A Tree Review of
The Proposed Demolition of an Existing Residence and
Construction of a New Custom Residence
15310 Suview Drive
Los Gatos, California 95032

Property Owner: Jim and Holly Vergara
Architect: Camargo & Associates, Inc.
APN: 537-24-024
Zoned HR-2½

Robert Moulden
Los Gatos Town Arborist
ISA Certified Arborist: #WE-0532A

July 18, 2019

Trees #1 through 8. Redwood trees.

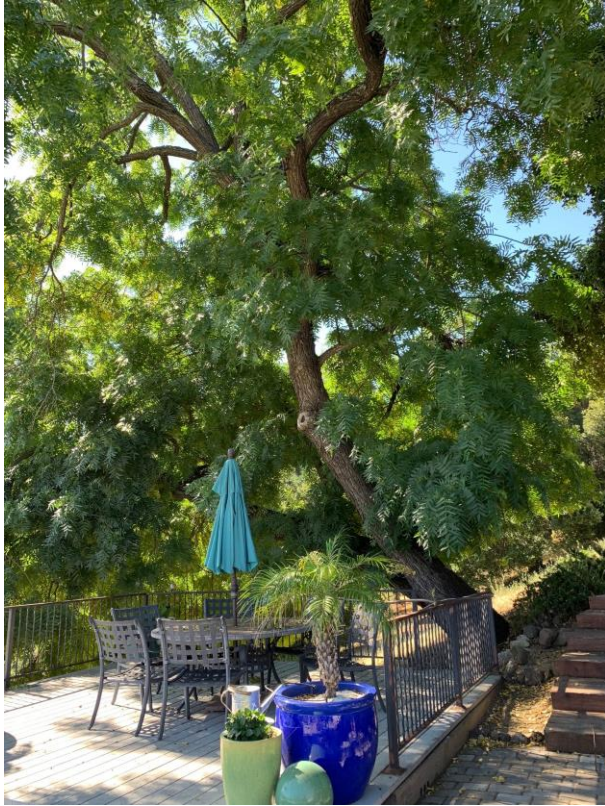
Trees #1 through 8 are young redwood trees located north of the proposed residence with diameters ranging from approximately 4 inches to 10 inches. The trees are in good health and show nice vigor. A portion of the proposed driveway would require the removal of trees #1 through 3.

Trees #1 through 3 are proposed for removal to accommodate the proposed driveway. Tree #9 is also proposed for removal. A tree removal permit is required for their removal and replacement plantings shall comply with the Town Code and Hillside Development Standards and Guidelines.

Trees #4 through 8 are proposed to remain and shall be protected for the duration of this project. Standard protection measures are appropriate to protect the trees during construction per Section 29.10.1005 of the Town Code.

Tree #9. Walnut tree proposed for removal.

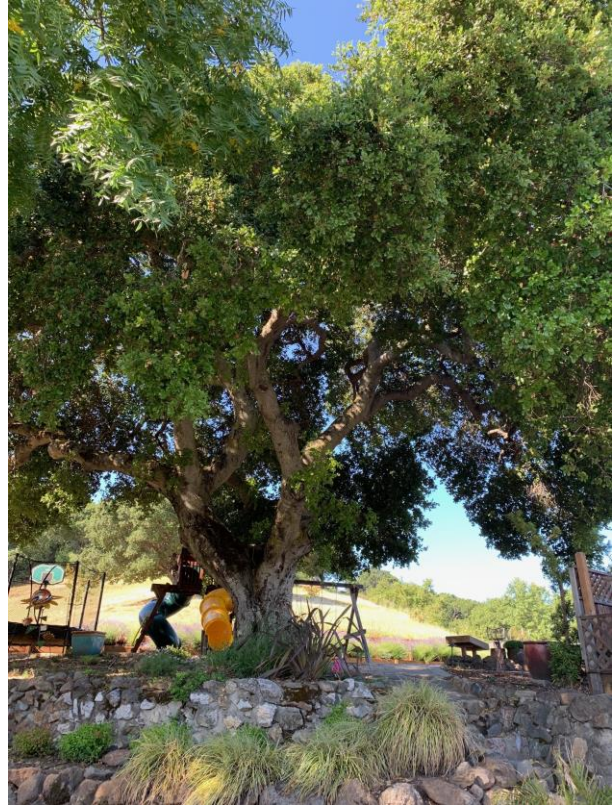
Tree #9 is a multi-trunk walnut tree with a diameter of approximately 48 inches. Based on its size and species of the trees, they are all classified as a large protected tree. This tree is located south of the proposed residence and has a significant lean to the east. This tree appears healthy and shows good vigor; however, since this tree has such a heavy lean, its removal could be supported if applicant agrees.

Tree #10. Oak tree proposed to remain.

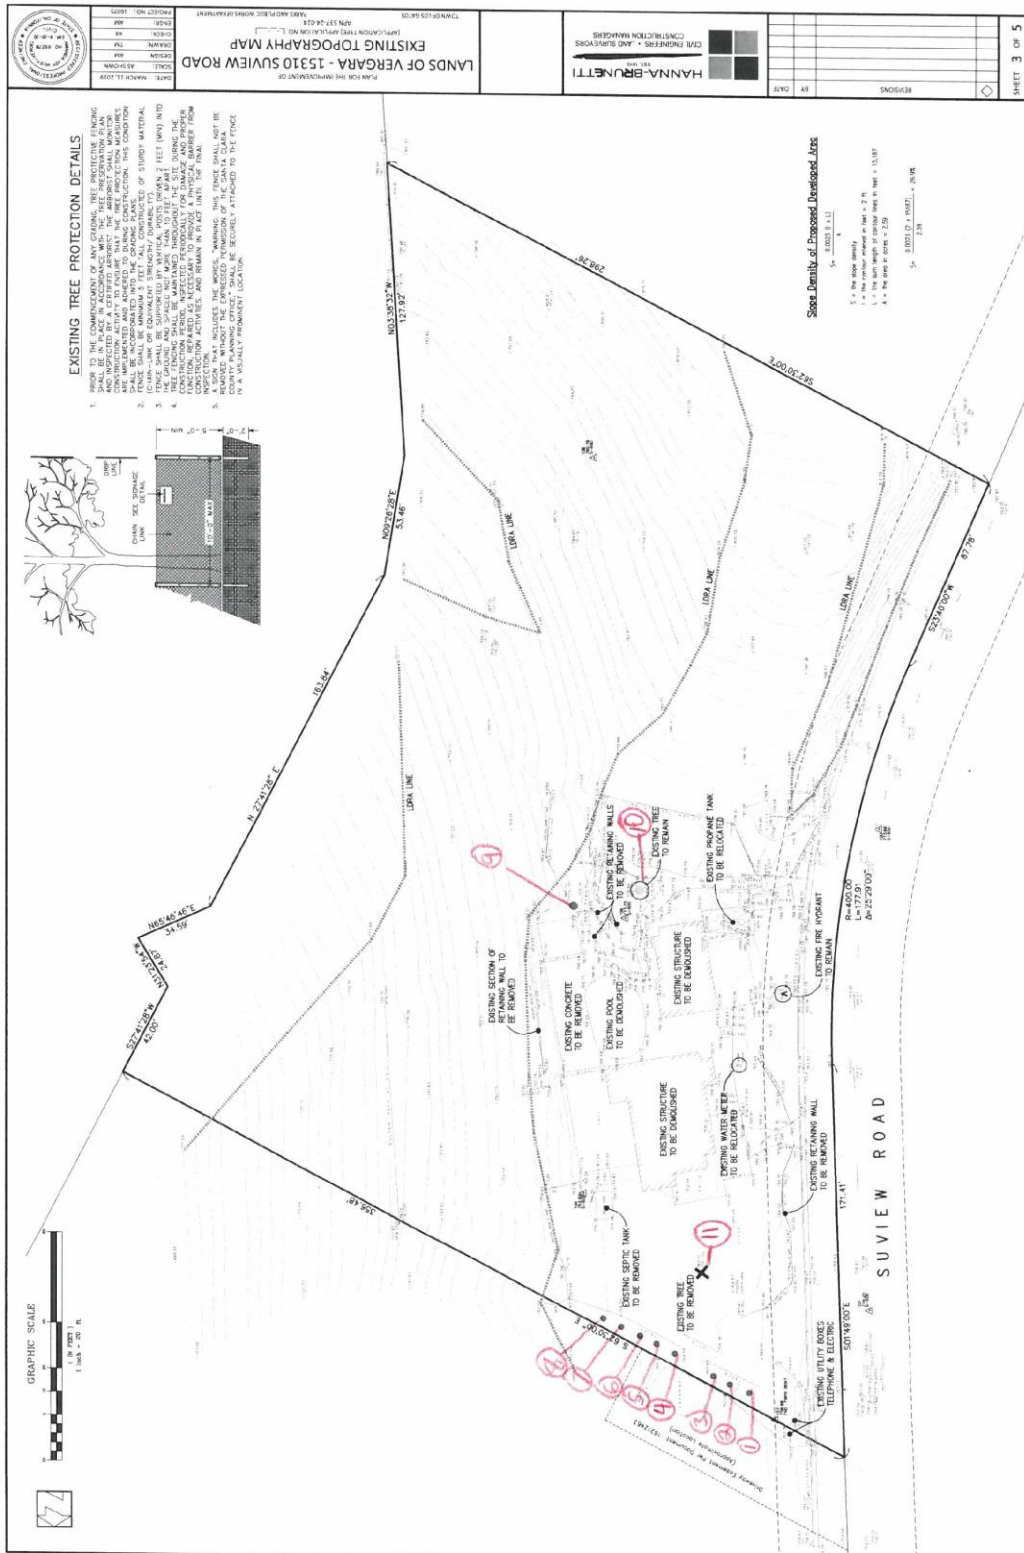
Tree #10 is a live oak with a diameter of approximately 50 inches. Based on its size and species of the trees, they are all classified as a large protected tree. This tree is located south of the proposed residence, adjacent to an existing swimming pool and play area. This tree is showing good health.

Trees #10 is proposed to remain and shall be protected for the duration of this project. Tree protection fencing shall be placed at the dripline of the tree to the greatest extent possible and shall meet the requirements of Section 29.10.1005 of the Town Code.
